SUMMARY OF SUBMISSIONS Karbro Drive, Cardup 26 (L87) 143801 – Section 31 Reconsideration – SJ4210

10.1.1 - Attachment 1

10.1.1 - Attachment 3

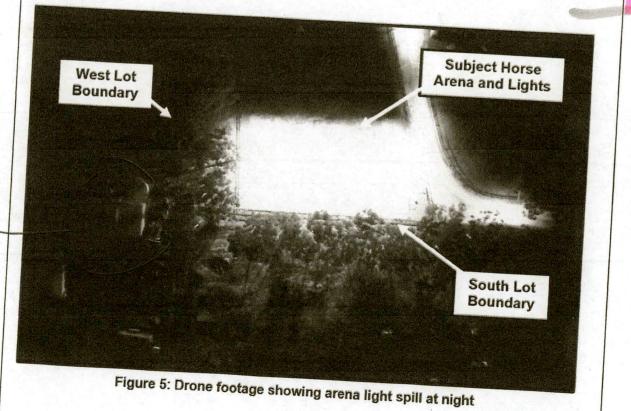
In terms light spill, the application confirms that the lights have been angled to a 14-degree angle which results in light spill occurring to a depth of 3m to the property to the south. Officers note however, that based on the aerial drone image below the spill appears to be greater. To address this, Officers consider light shields can be installed which angles light in a controlled manner inside the property, avoiding light spilling outside of the boundary. A condition requiring further angling of the lights, or light shields being installed, is also recommended in order to reduce spill to no more
